Video Products Technical Bulletin 30-2009-149

SUBJECT: **REUSE TRANSFORMERS WHEN REPLACING G BOARD**

MODEL: ***BVM-D9H1A***
BVM-D9H1E
BVM-D9H1U
BVM-D9H5A
BVM-D9H5E
BVM-D9H5U

Figure 1

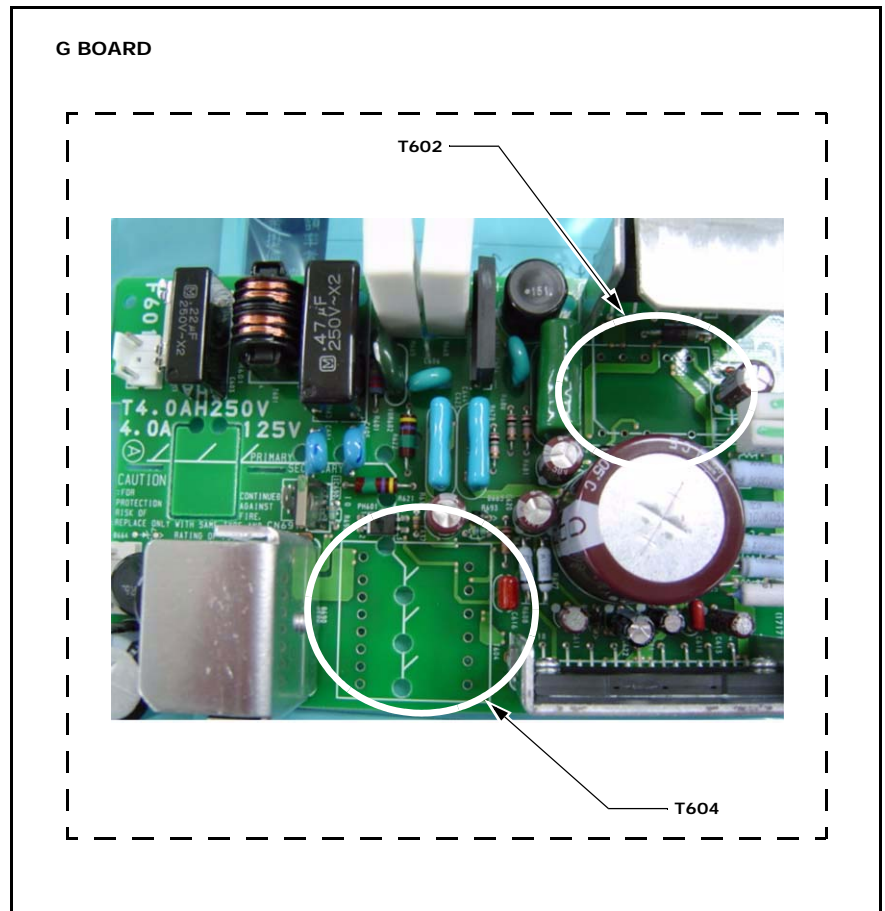
When replacing the G board (A-1316-460-A/B/C), remove the following transformers from the former board and install them on the new board.

Ref. No.	Description
T602	Ferrite transformer (PFT)
T604	Converter transformer (PIT)

The new G board does not contain the transformers, and the transformers are no longer available as service parts. (See Figure 1.)
